## STAFF REPORT COMMUNITY DEVELOPMENT DEPARTMENT

HEARING DATE: November 9, 2021

SUBJECT: H-2021-0042  
Intermountain Wood Products Expansion

D. Site Plan (date: ~~1/12/2021~~ 10/7/2021)

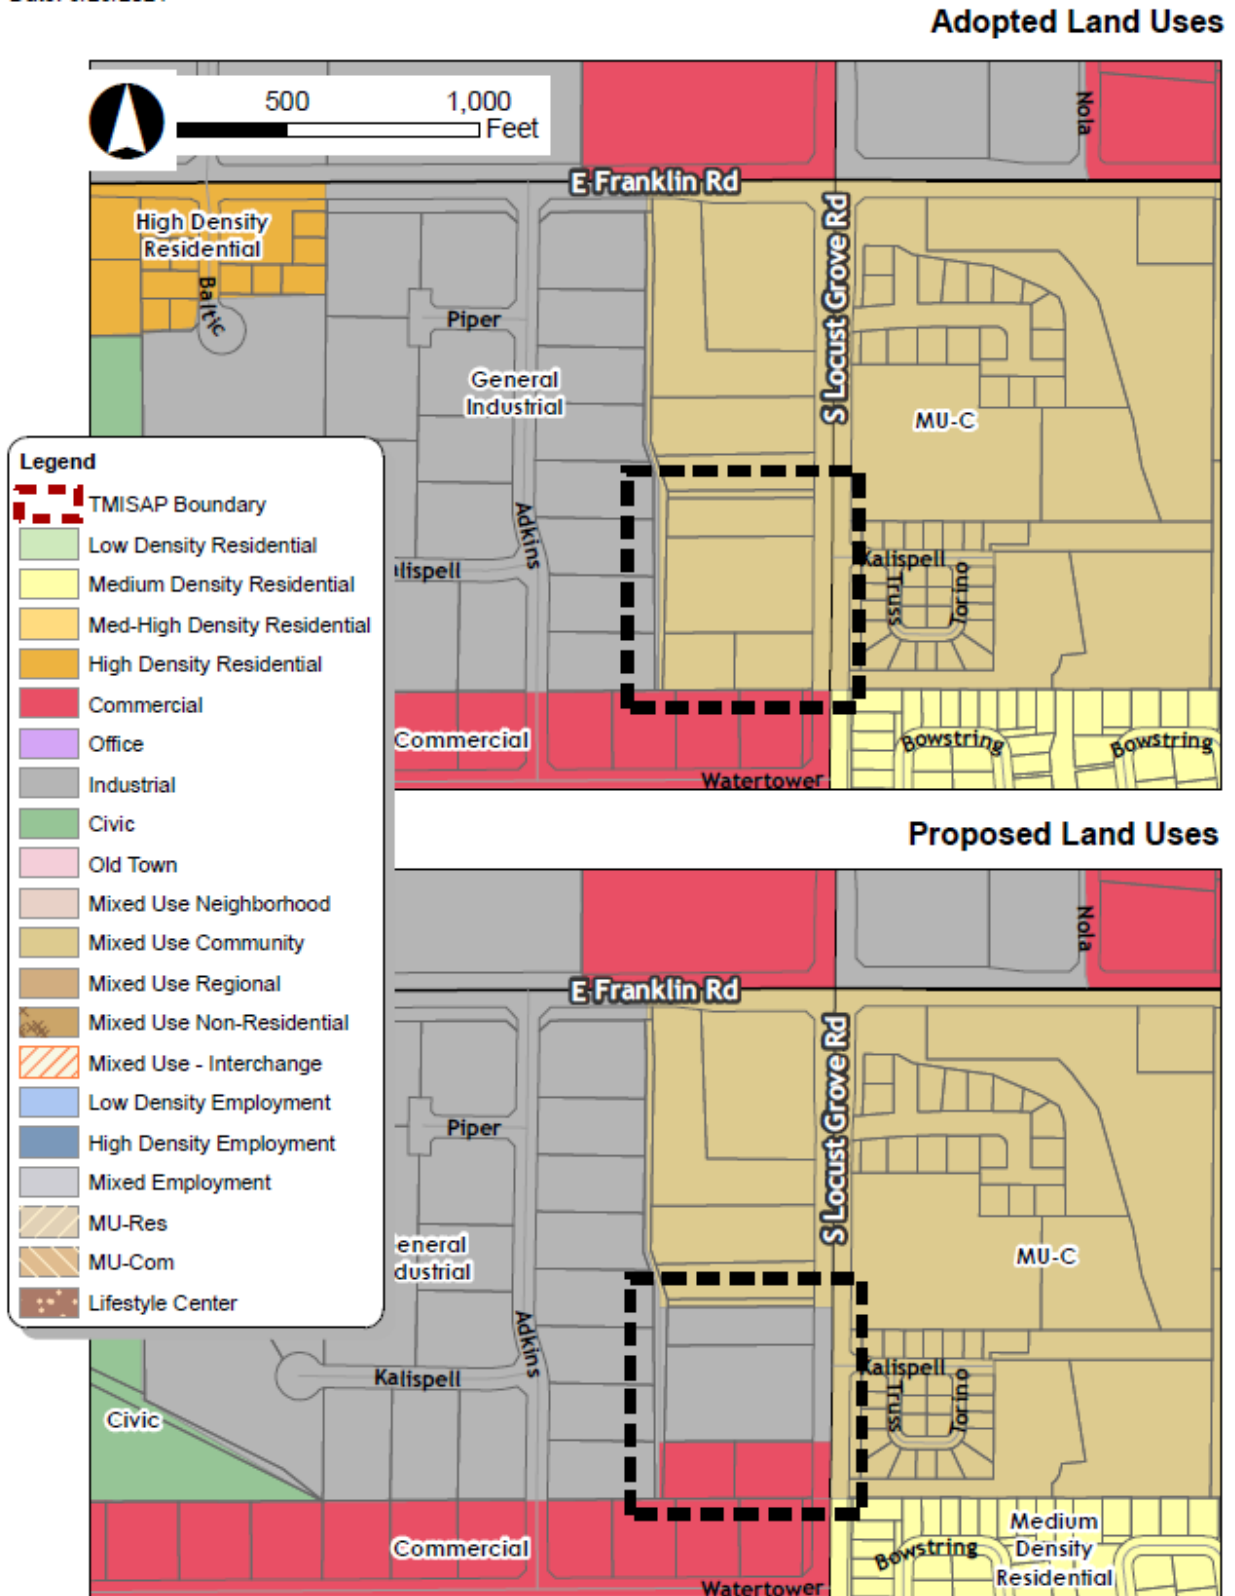
*Staff does have concerns regarding the present concept plan as will be discussed in the dimensional standards section below. Staff has red-marked on the concept plan that this plan should not be approved and future development should comply with all pertinent regulations and the Architectural Standards Manual.*

*The concept plan indicates primary access, including for trucks, occurring directly from S. Locust Grove, an arterial. Also, staff has recommended to the applicant that cross access be provided to the properties to the north and south, although the concept plan does not reflect this. Staff has addressed this in the conditions of approval.*

The site and design standards of UDC 11-3A-19 state that for properties greater than two (2) acres in size, no more than fifty (50) percent of the total off street parking area for the site shall be located between building facades and abutting streets. The concept site plan as submitted shows the entirety of the parking between the building and S. Locust Grove Rd.

UDC 11-3A-19 also requires an applicant to extend or improve streets, drive aisles, cross access easements or similar vehicular and pedestrian connections provided from adjacent properties. The concept plan as submitted does not provide access to the properties to the north and the south. As a condition of approval of the development agreement, staff is recommending cross access to these adjacent properties.

Staff does have concerns with the concept site plan as submitted because of the comments listed above. Staff has additional concerns regarding the size and visibility of the proposed warehouse

as would be viewed from S. Locust Grove Rd., and is unsure the building as shown would meet all the requirements of the Architectural Standards Manual (ASM). Although staff is overall supportive of annexation of the property for the purpose of the expansion, staff believes additional revisions need to be made to the site plan in order to be consistent with the regulations. Staff is not supportive of the concept plan as submitted.

S. Locust Grove Road is classified as an arterial roadway and is improved with 5-travel lanes, bike lanes, vertical curb, gutter, and 7-foot wide sidewalk abutting the site. The concept plan as submitted shows access for this site occurring via a 40 ft. driveway directly from S. Locust Grove Rd. The applicant has mentioned employee, customer and truck access could occur at this driveway. ACHD has noted this proposal complies with all ACHD requirements. The Council can grant a waiver to allow the access, but staff prefers the applicant develop the site plan with internal circulation and send trucks through S. Adkins Way as previously discussed at the pre-application meetings.

Staff has concerns with access occurring from S. Locust Grove Rd. UDC 11-3A-3 states where access to a local street is available, the applicant shall reconfigure the site circulation plan to take access from such local street. Also, where access to a local street is not available, the property owner shall be required to grant cross-access/ingress-egress and extend or improve streets, drive aisles, cross access easements or similar vehicular and pedestrian connections provided to adjacent properties.

During the March 2021 Pre-Application meeting, it was mentioned to the applicant that the site plan as submitted should be revised to remove primary access from S. Locust Grove, access should be provided to the properties to the north and south, and it would be preferable for truck access to occur via the existing driveway from S. Adkins Way. The concept plan as submitted does not reflect any of these access points. As a condition of approval, staff recommends the access from S. Locust Grove Rd be closed, and the site plan be revised to indicate access from the north, south and west.

UDC 11-3C-6 requires one space for every 2,000 sq. ft. of gross floor area for industrial uses (warehouse). Based on a 53,350 sq. ft. warehouse and 4,800 sq. ft. of office space this amounts to 27 parking spaces required whereas 44 are provided. However, as mentioned above in the dimensional standards section above, the parking configuration as shown on the site plan does not comply with UDC 11-3A-19 in that all parking area is located between building facades and abutting streets.

11-3C-5 requires all off street parking areas to be provided with a substantial wheel restraint to prevent cars from encroaching upon abutting private and public property or overhanging beyond the designated parking stall dimensions. When a bumper overhangs onto a sidewalk or landscape area, the parking stall dimensions may be reduced two (2) feet in length if two (2) feet is added to the width of the sidewalk or landscaped area planted in ground cover. The concept plan does not appear to meet either of these requirements.

- a. Commission noted the updated site plan that was presented at the meeting should be approved with a revision showing a northern cross access to the property at 255 S. Locust Grove Rd.
- b. Commission recommended approval with staff's recommendations and the additional recommendation that Council approve the S. Locust Grove Rd access.

- b. **Future development of this site shall be generally consistent with the conceptual site plan dated October 7, 2021 included in Section VII and the provisions contained herein.**

- c. The S. Locust Grove Rd. access ~~shall be used for emergency access only, unless waived by City Council in accord with UDC 11-3A-3~~ **shall only be used Monday-Friday between 7AM to 5PM.**

- d. Cross-access easements shall be granted to the abutting property to the north (Parcel # S1118110071) and south (Parcels # R0879824125 and R0879824130); a copy of the recorded easement shall be submitted to the Planning Division with the Certificate of Zoning Compliance application for this site.
